## Hudson River PCBs Superfund Site

Subject: Review of Selected Data Targets for General Electric Upper Hudson River Modeling System

Figure 1. Model Total Suspended Solids vs. Measure Total Suspended Solids (Near-Field PCB Release Mechanism)

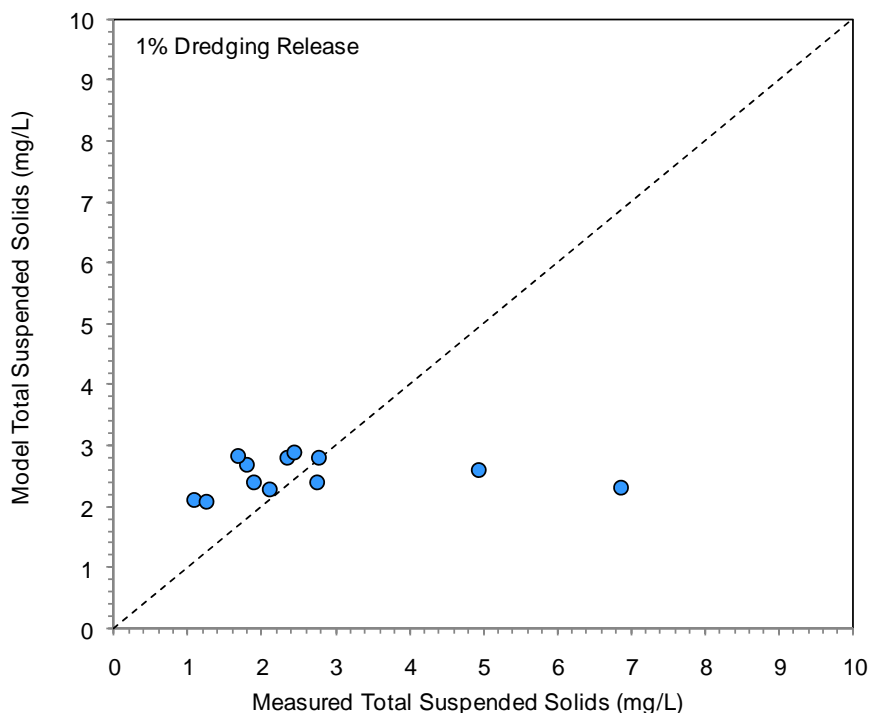
The conceptual model for PCB and solids release during dredging assumed a one-to-one correspondence between solids release and PCB release at the dredge head. For the near-field release mechanism, a solids release of 1 percent was a better fit to the observation (see Figure 1). However, for dissolved phase PCBs, a 5 percent release was the better fit (see Figure 2). This indicates that the processes controlling PCB dynamics are more complex than the simple release of solids represented in the AQ model. The Peer Review Panel called for the formulation of a conceptual site model that encompasses all the mechanisms for PCB release, and the development of a new or updated model that can be used to project PCB fate and effects with a higher degree of confidence than is currently available. Other factors that affect near-field conditions include, but are not limited to: PCBs in the form of non-aqueous phase liquid, boat traffic, backfill, and open CUs upstream of the study area. Therefore, during the first year of Phase 2, adequate data needs to be collected in the near-field to ensure that the model is well constrained, and that the mechanisms for PCB fate and transport are better understood and formulated so that the model can be appropriately calibrated.
